Diamond
AIRCRAFT

Service Bulletin No.: DA20-27-07 Rev. 0

Title: Rudder Pedal Adjust System

Figure 1

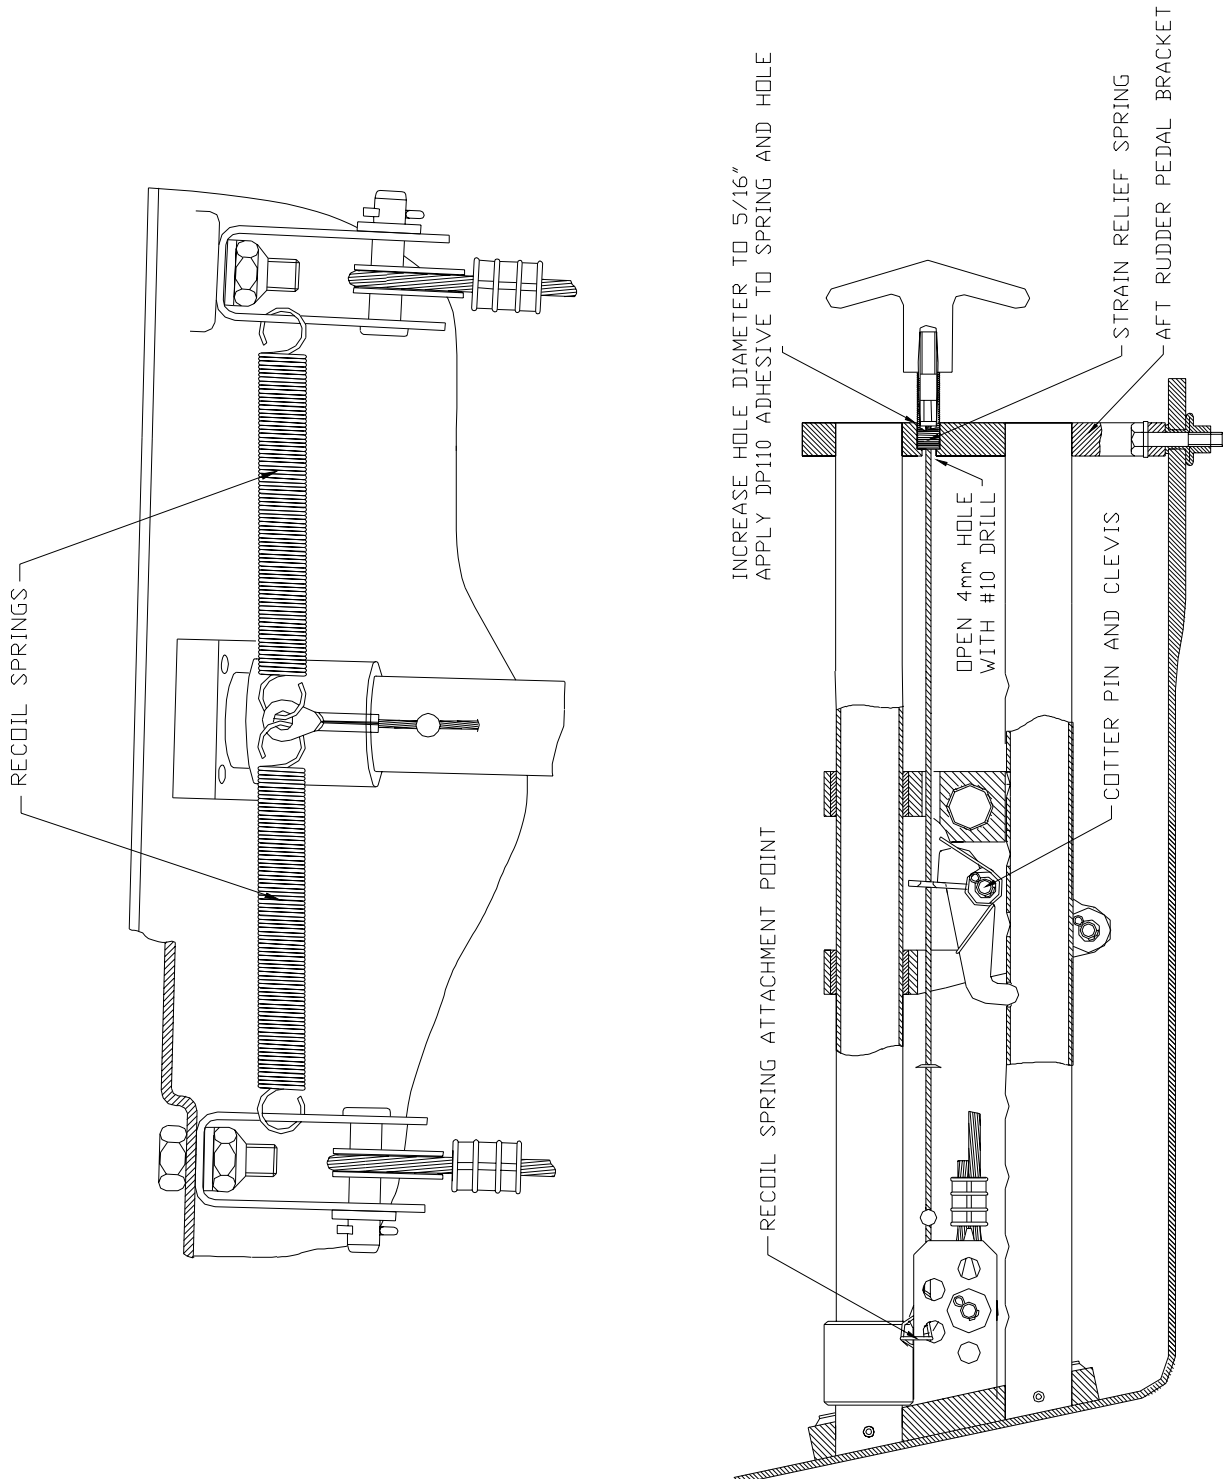
- 10.8 Install the new latch as the previous was installed. Refer to Figure 1.
- 10.9 Hook the recoil springs to the rudder cable brackets and cable assembly as shown in figure 1.
